FIRE SAFETY INSPECTION REPORT

Brothers Fashion Ltd.

ACCORD ID: 12620

**Inspected By: Nusrat Hossain Trisha, Nasif Javed Tofa
Date: 16 October, 2016**

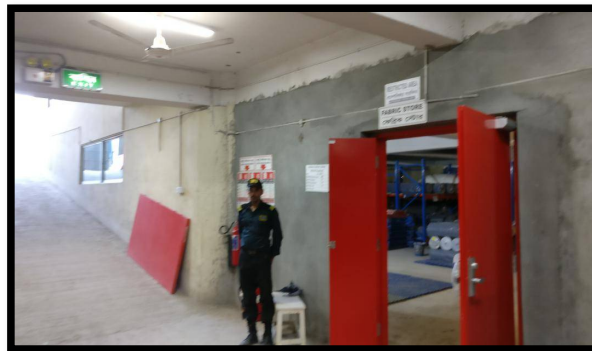
SI No.	Category	Findings	Required Action	Remediation Time Frame
F-1	Fire Rated Construction	Boiler, Generator, Compressor, Diesel Storage & Transformer room are not properly separated by fire rated construction with other Occupancies/Areas. Location: Basement & ground floor. <u>Note</u> : Fire separation work was going on during the inspection.	Boiler/ Generator/ Compressor/ Diesel storage/ Transformer room shall be separated from other occupancies by a minimum 2-hr fire rated construction (wall, floor, slab etc.). Seal all penetrations and openings (door, window etc.) should be protected by 1.5-hr fire rated materials to maintain the fire separation if required. All exhaust systems shall discharge to the exterior of the building in a safe location.	Within 3 months

Unprotected opening on staircase

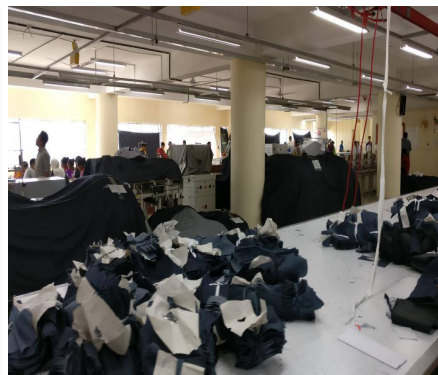
F-4	Fire Rated Construction	<p>The exit stairs are not properly separated from [work areas, other spaces] on each floor by fire-rated construction.</p> <p>Note: Fire separation work is going on. Interfacing with FACP for the doors are required as factory is keeping the doors open.</p>	<p>Stair shall be enclosed with a minimum 2-hr fire-rated construction. Seal all unprotected openings and provide minimum 1.5-hr fire rated doors to separate the exit stairs from work areas and other building spaces on all floor levels. Ensure that the fire doors are self-closing, positive latching and that they are provided with fire exit (panic) hardware where serving production floors.</p> <p>If fire doors are required to be held open for functional reasons, provide automatic-closing devices tied to the fire alarm system.</p>	Within 3 months
-----	-------------------------	---	--	-----------------

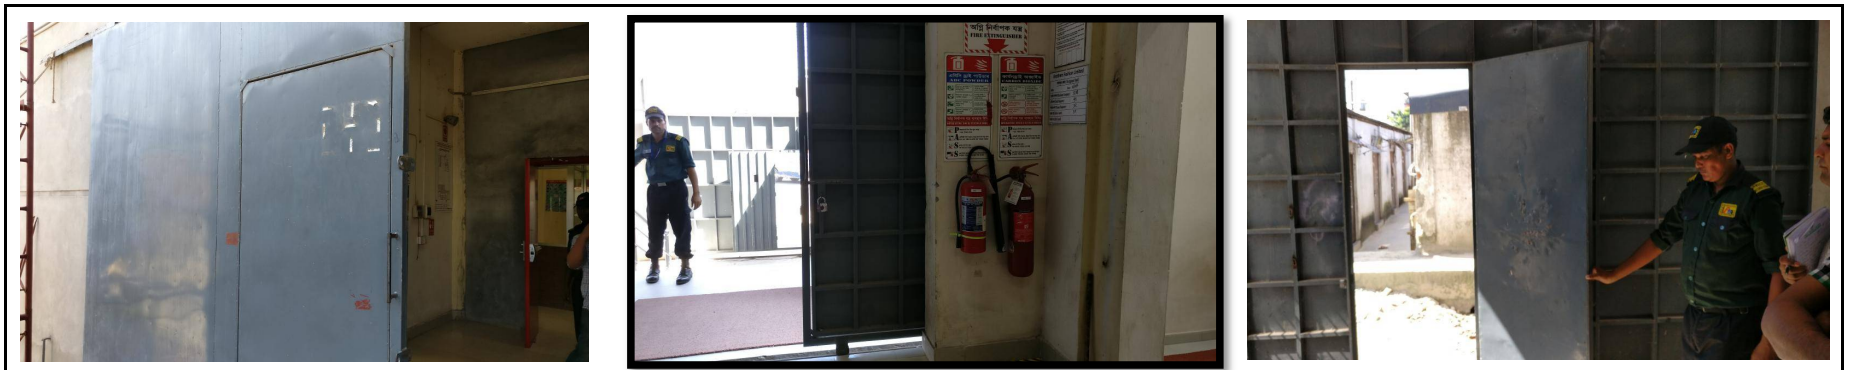
F-7	Egress	Non compliant gates/ Sliding doors are provided at ground floor [building exits, along egress routes, exit discharge]	<p>Replace all non-compliant gates along the means of egress with side-hinged, swinging egress doors.</p> <p>If locks are required for security reasons, utilize specialized door locking features complying with NFPA 101.</p>	Within 1 month
-----	--------	---	---	----------------

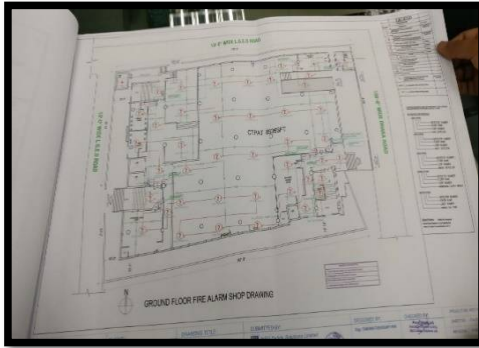
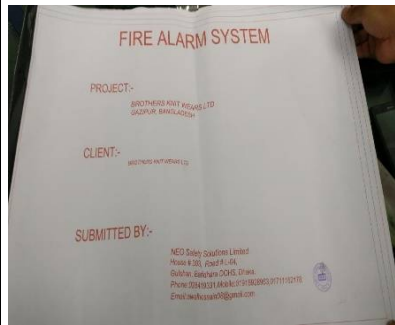
F-12	Fire Detection & Alarm System	Fire detection system installation has been just started & requires detailed review to confirm compliance with NFPA 72 and ACCORD standards	Provide listed addressable fire alarm system in accordance with NFPA 72. Submit drawings, equipment certification and other relevant documentation to the ACCORD for review and approval, installation shall have to done as per the reviewed design.	Design within 4 month; Installation within 9 months
------	-------------------------------	---	---	--

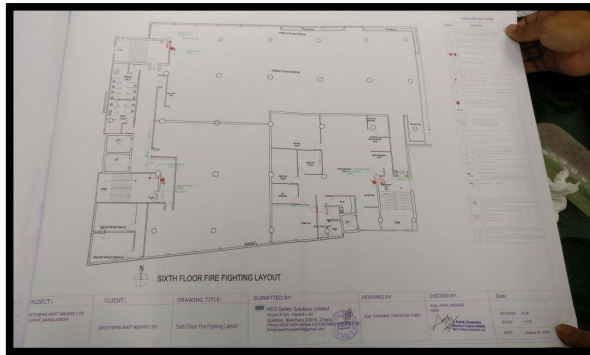
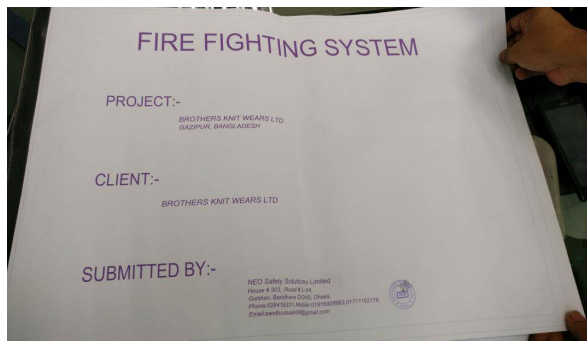
F-14	Fire Protection System	The existing factory building with an occupiable floor greater than 10 m (33 ft) above the finished grade is not protected with an approved standpipe system.	Install a new class III standpipe system & fire department connection in accordance with NFPA 14. Submit drawings, equipment certification and other relevant documentation to the ACCORD for review and approval, installation shall have to done as per the reviewed design	Design within 4 month; Installation within 9 months
------	------------------------	---	---	--

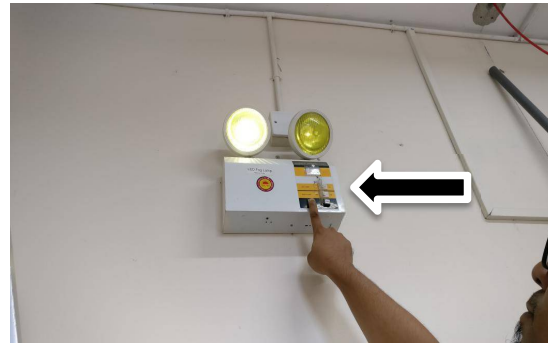
F-17	Egress Lighting	Manual on-off switch facility available for emergency lights in several floors.	Remove manual on/off switches from emergency lighting units to prevent them from being switched off.	Within 1 month
------	-----------------	---	--	----------------
